SERVICE BULLETIN

Improved Fuel Gravity Feed Hose

1.1 Effectivity: All AS202/18A/18A1/18A2/18A3/18A4 aircraft up to and including serial

ACRO FUEL PIPE MODIFICATION FOR AIRCRAFT AS202/18A1/18A2/18A3/18A4

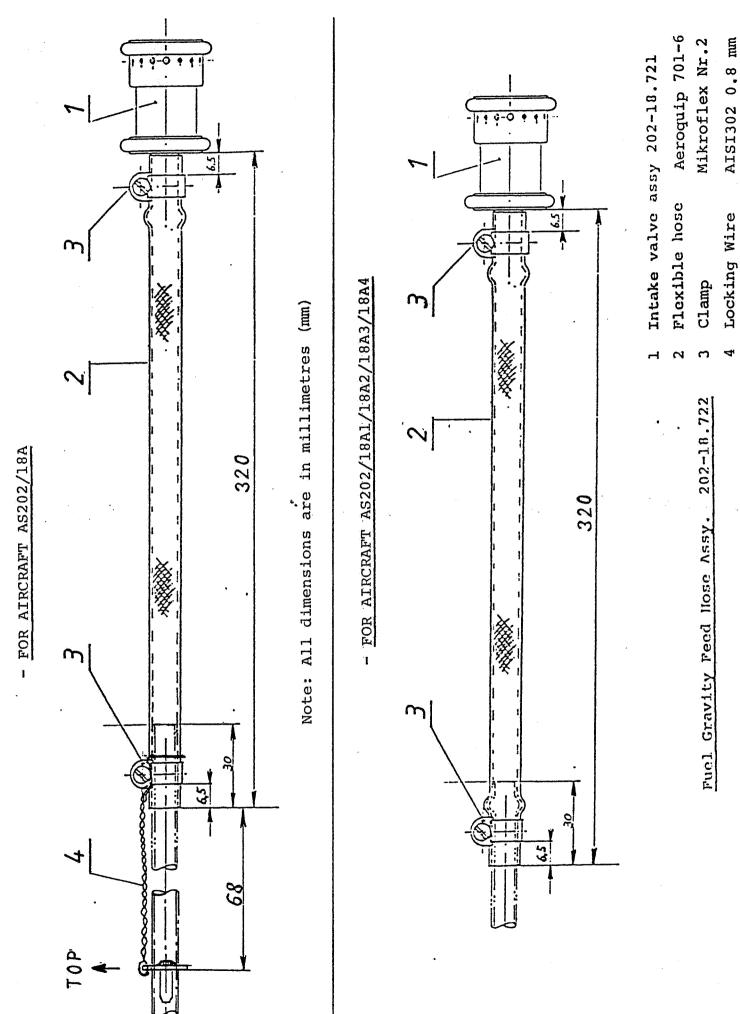
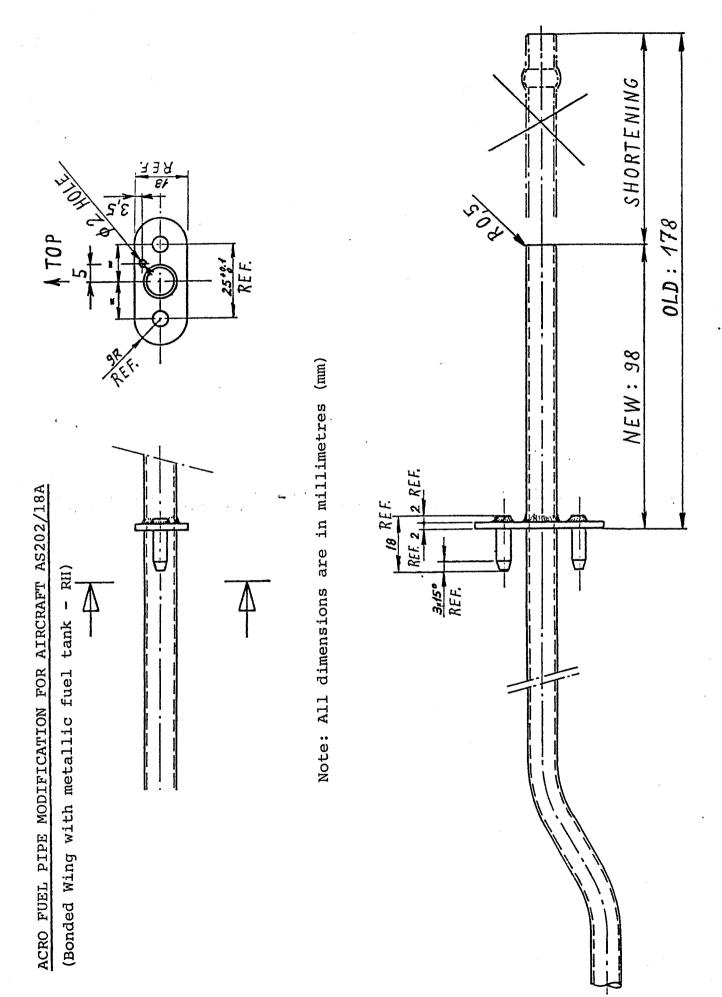
- 2. Procedure for AS202/18A1/18A2/18A3/18A4.
- 2.1 Drain fuel from right side or both tanks as necessary.
- 2.2 Remove inboard fuel level sensor from aerobatic tank(s), having ensured that relevant circuit breakers are OFF.
- 2.3 Disconnect rigid Acro fuel pipe in each applicable tank from the tank wall fitting and detach the spigots from the pipe support assembly.
- 2.4 Remove pipe assembly through the level sensor access hole.
- 2.5 Disassemble and discard the old flexible hose and spring. Retain the intake valve and clamps.
- 2.6 Obtain new rigid pipe assembly or rework the original pipe as per the attached drawing on page 7. (This involves shortening the tube by 80 mm. and reforming the bulged area). Remove any burrs.

- 2.7 Assemble the new flexible hose assembly to the dimensions on the accompanying diagram on page 5, using the clamps and intake valve retained in step 2.5.
- 2.8 Refit the flexible hose assembly and sensor unit.
- 3. Material

Flexible Hose. 202-18.722.12 (Aeroquip 701-6, length 320 mm).
